**Panel Report**

**Surf Coast Planning Scheme Amendment C114**

**Spring Creek Precinct Structure Plan**

**23 January 2017**

Figure 8 Native Vegetation Precinct Plan – Map 2 Native vegetation to be retained and removed

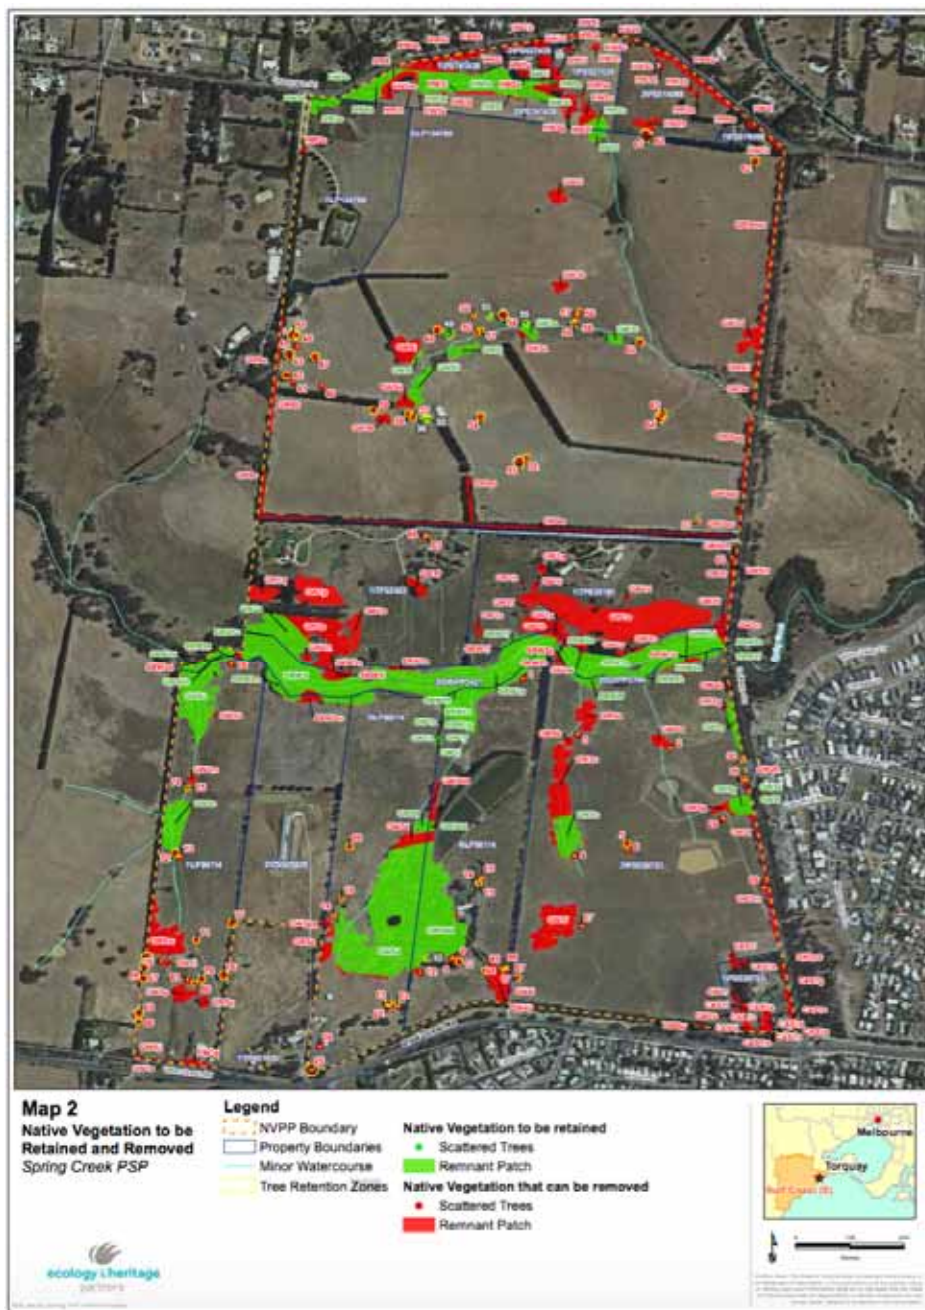
Council submitted that the NVPP sets out the native vegetation to be removed and retained (see Figure 8 below), and it considers native vegetation for practical retention. This process is undertaken on the principles of avoid and minimise losses of remnant vegetation.

Council submitted that the process to identify vegetation for protection in the NVPP was informed by the Biodiversity Assessment prepared by Ecology and Heritage Partners “*which made recommendations for the prioritisation of the retention of areas of the highest conservation value*”.

13. Amend the wording of R23 of the Precinct Structure Plan to allow for a permit application to remove native vegetation identified for protection in the Native Vegetation Precinct Plan.
14. Council consider using the best part of GW5 as a net gain native vegetation offset, with consideration of appropriate public access that manages identified threats and protects the values of the biodiversity asset.
15. Remove SRW1 from the Precinct Structure Plan and Native Vegetation Precinct Plan as vegetation proposed for retention in a conservation reserve.
16. Review the status of native vegetation at 160 and 195 Grossmans Road, and amend the Biodiversity Assessment and Native Vegetation Precinct Plan accordingly.

Figure 9 PSP Plan 6 - Open Space and Community Facilities Plan

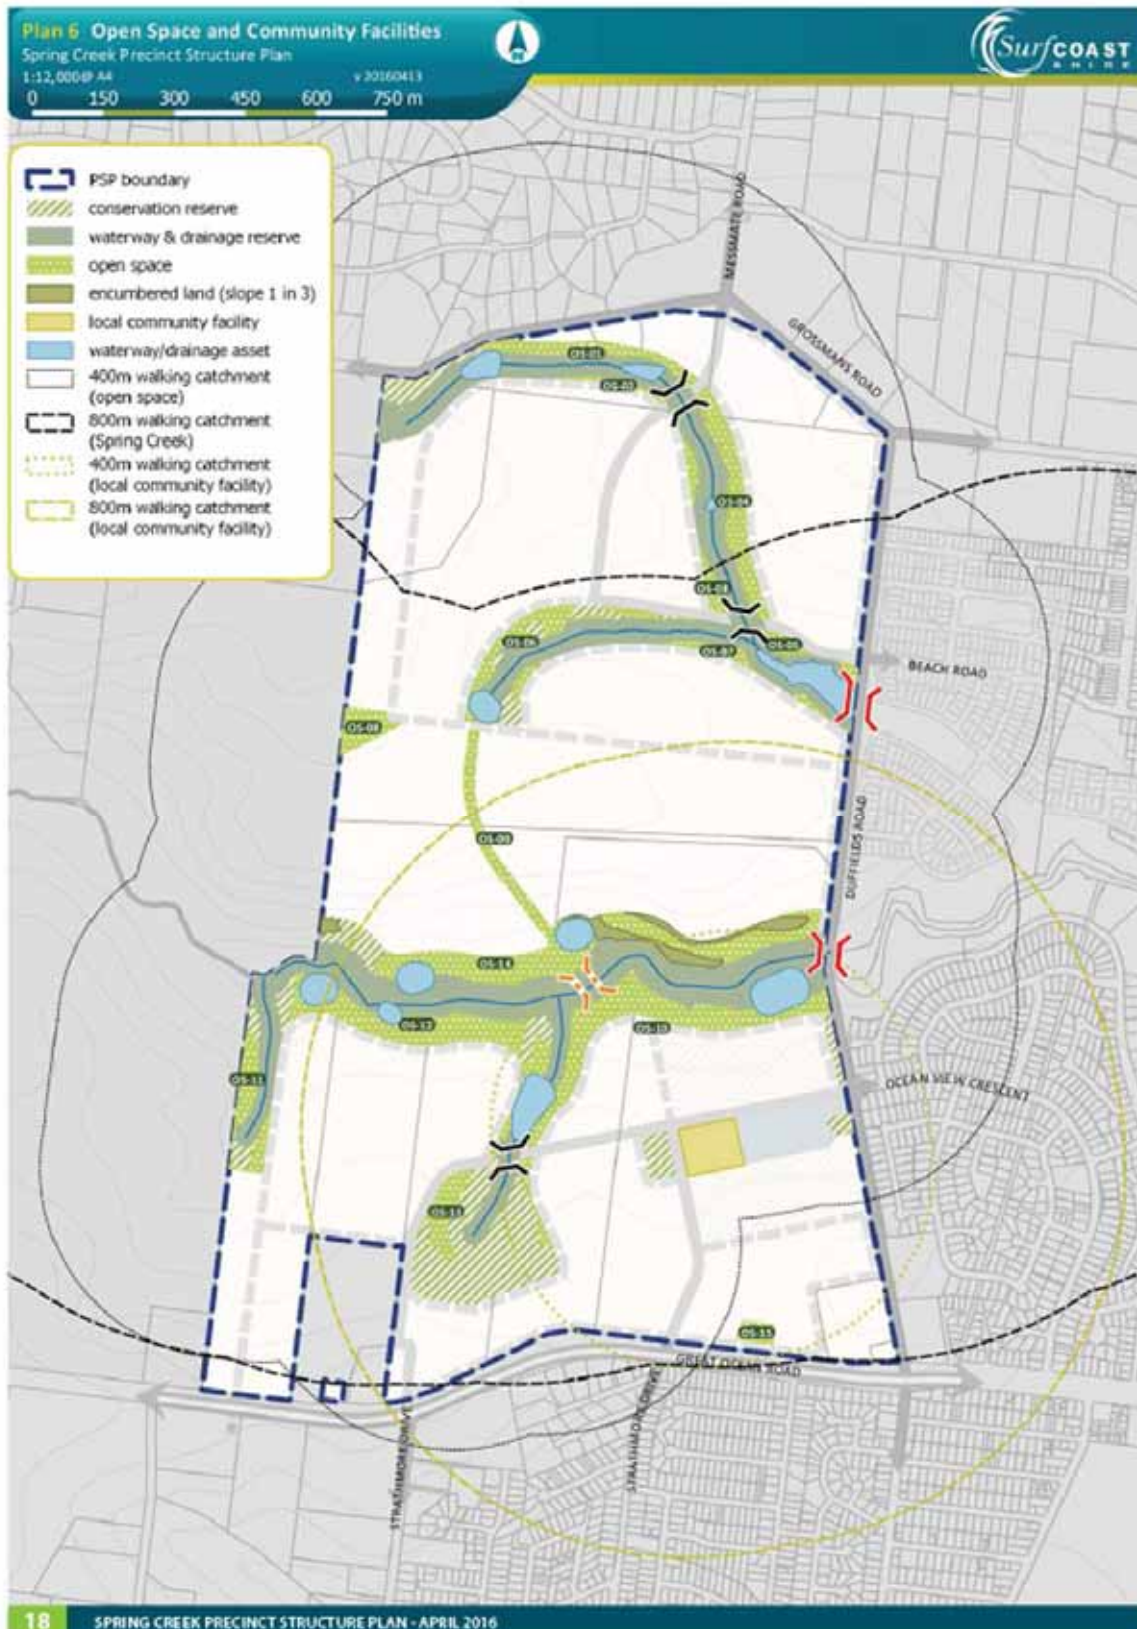
Council submitted that *“the precinct’s location within the Spring Creek valley provides an ideal opportunity for the provision of open space and an open space network”*. Figure 9 shows the location and distribution of proposed open space in the exhibited Spring Creek PSP.

Council commissioned ASR Research to prepare a Community Infrastructure Assessment (CIA) for the site which included recommendations relating to open space provision.

Figure 10 Alternate Draft Framework Plan  
Source: Mack submission (submitter 43), Appendix F

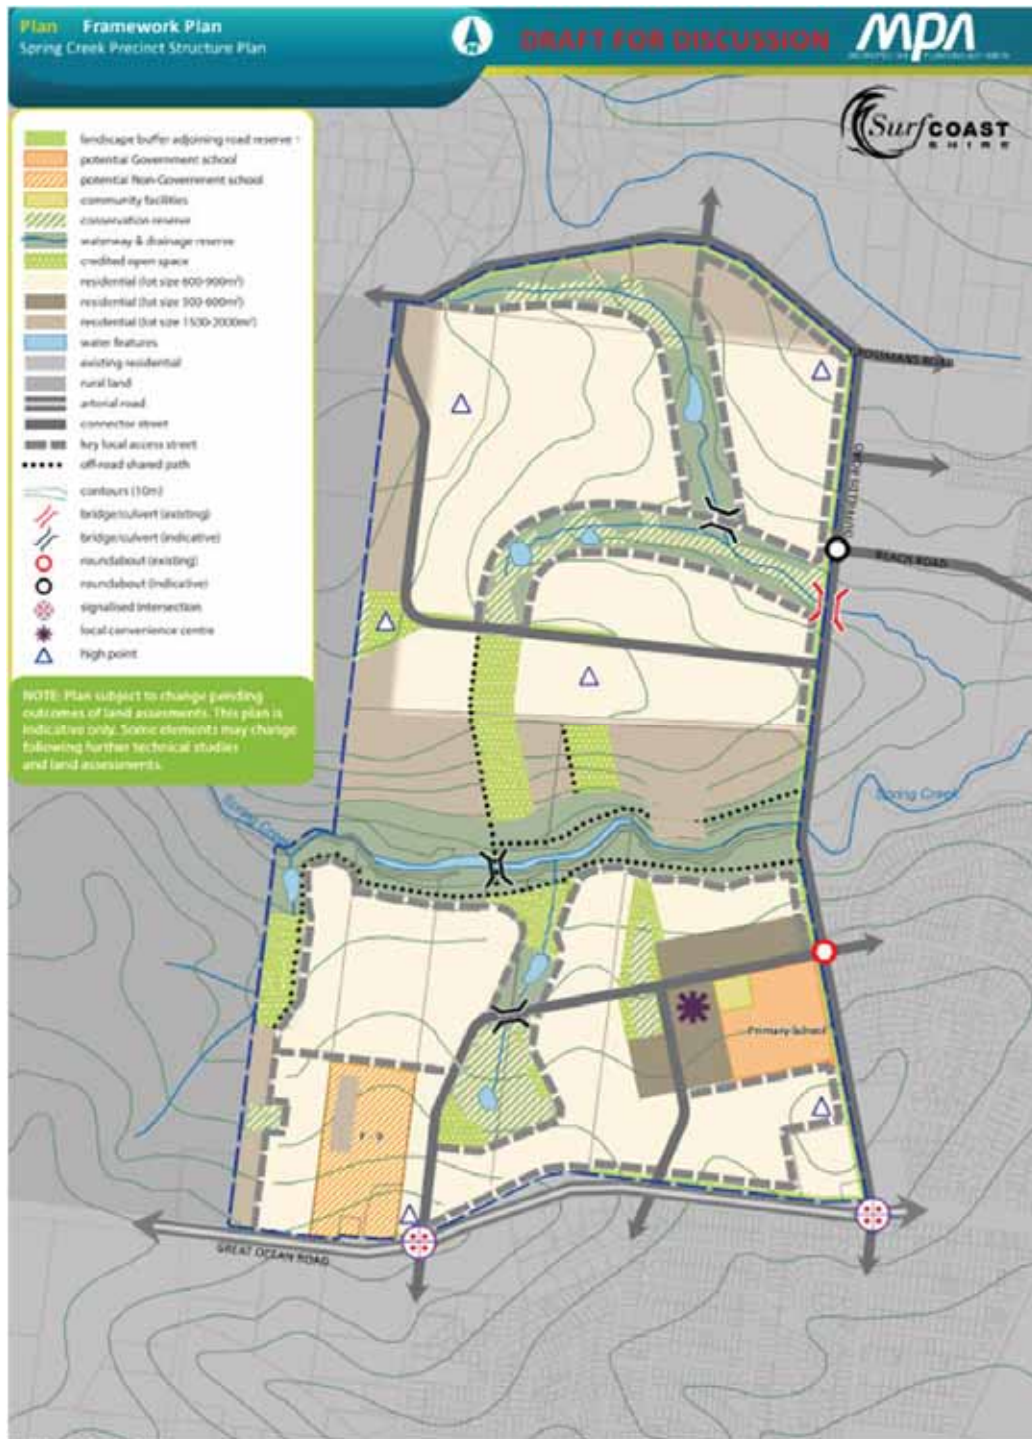
Mr Harvey gave evidence that it would appear that 200 – 220 Great Ocean Road had been disproportionately allocated larger areas of retained native vegetation (GW5) relative to other properties across the PSP (34 percent of total retained vegetation within the PSP), and that the alternative draft Framework Plan prepared by Niche Planning (see Figure 10) sets out a more appropriate and equitable distribution of conservation reserves.

Mr Harvey gave evidence that alternative Framework Plan focused on protecting the core of the patch and removing the requirement to retain the lower quality portion of the patch in the south west.

Figure 14 Plan 5 Spring Creek PSP

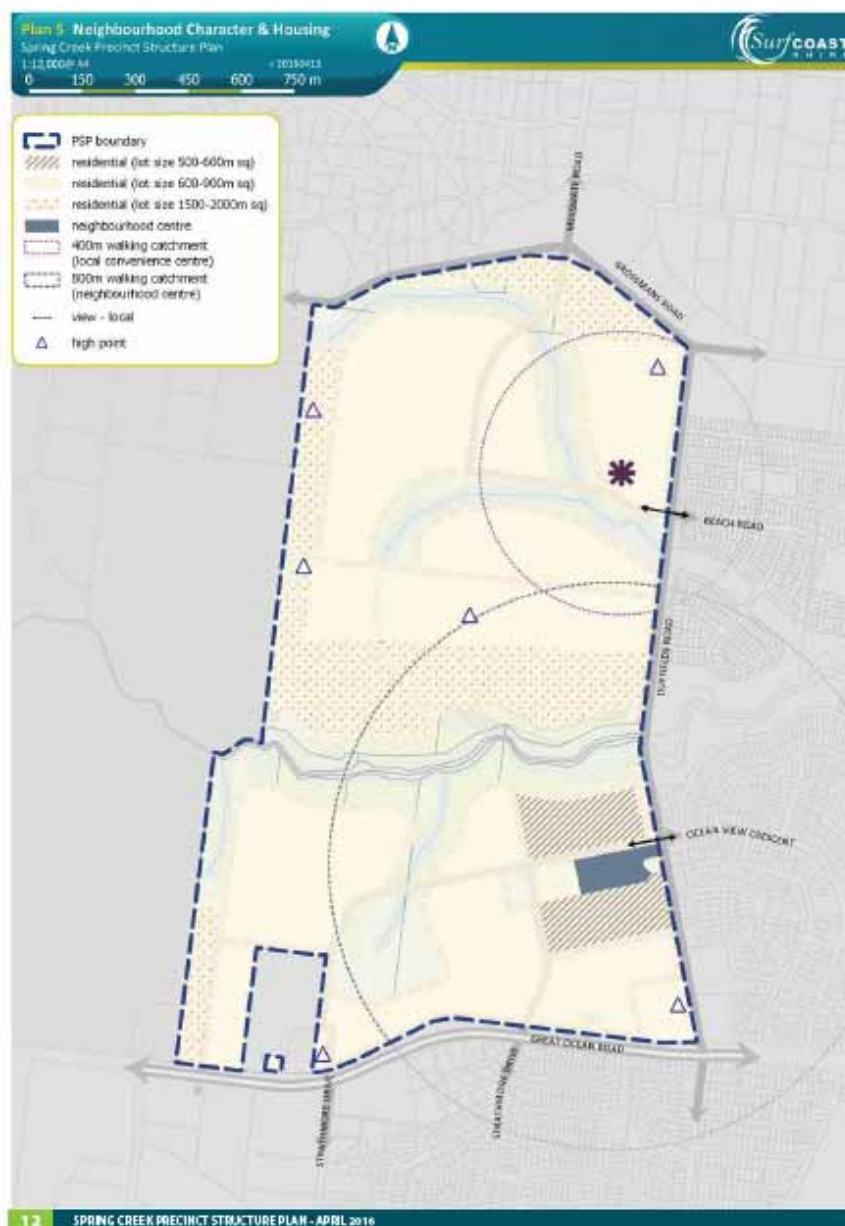
Council submitted that the PSP at pages 12 and 14, Plan 5 and Table 2 sets out the location of the various lot sizes. The PSP envisages an average density of 10 dwellings per net development hectare.

Council submitted that the Planning Scheme specifically states that lower densities should be provided in Spring Creek. The PSP achieves the objectives for this development area notwithstanding the lower density. Council opined:

29. Reinststate the asterix on Map 1 of the Urban Growth Zone and Plan 5 of the Precinct Structure Plan denoting a Local Convenience Centre in the northern precinct.

Figure 16 Map from Clause 22.09

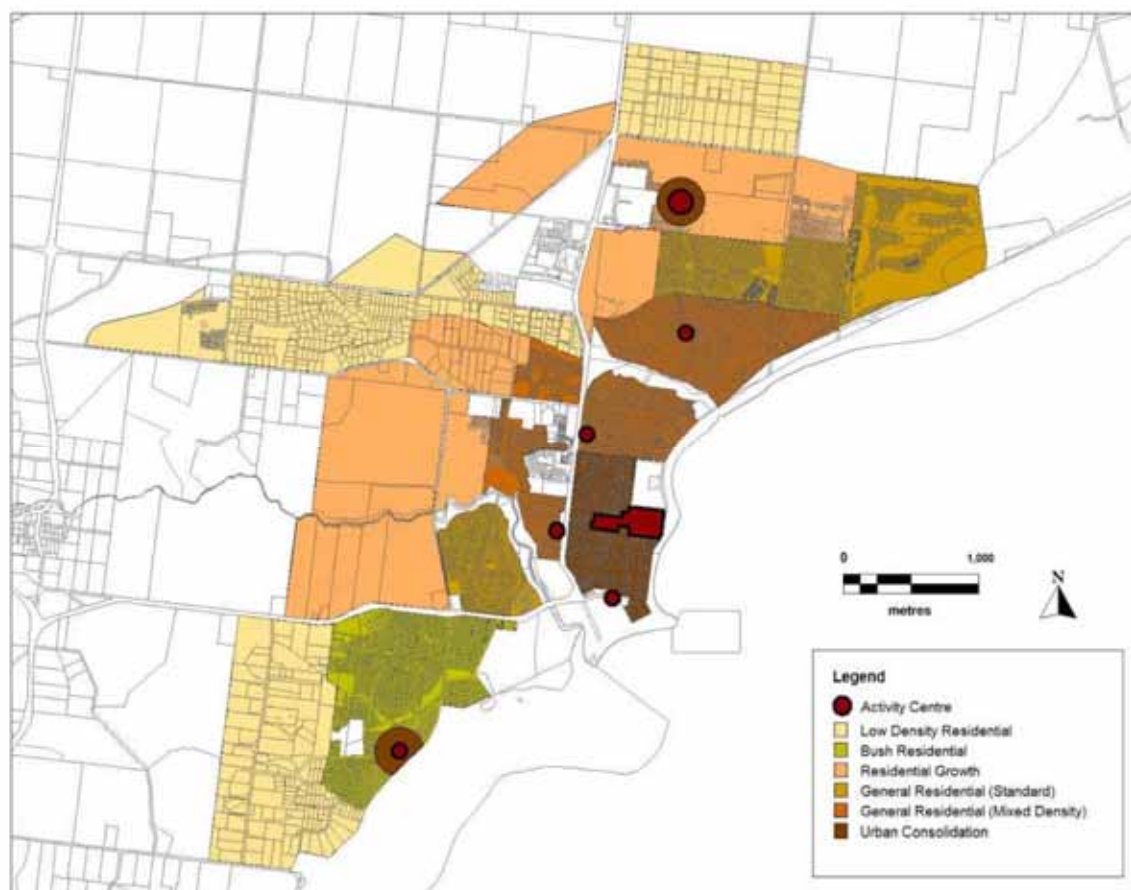
Council’s justification that the densities came about because the community expressed a desire for larger lots simply flies in the face of the fact that this land is zoned Urban Growth Zone, with a PSP being applied to it. To restrict densities in the locations closest to the NAC and Christian College is not a proper planning outcome. Higher density lots, as indicated in its own local policy at Clause 22.09 is a sound planning principle that is applied across growth areas across Melbourne.

The Panel believes that the vision for the precinct “derived from community aspirations was for a vegetated character, with larger allotments and low site coverage” will still be achieved even with
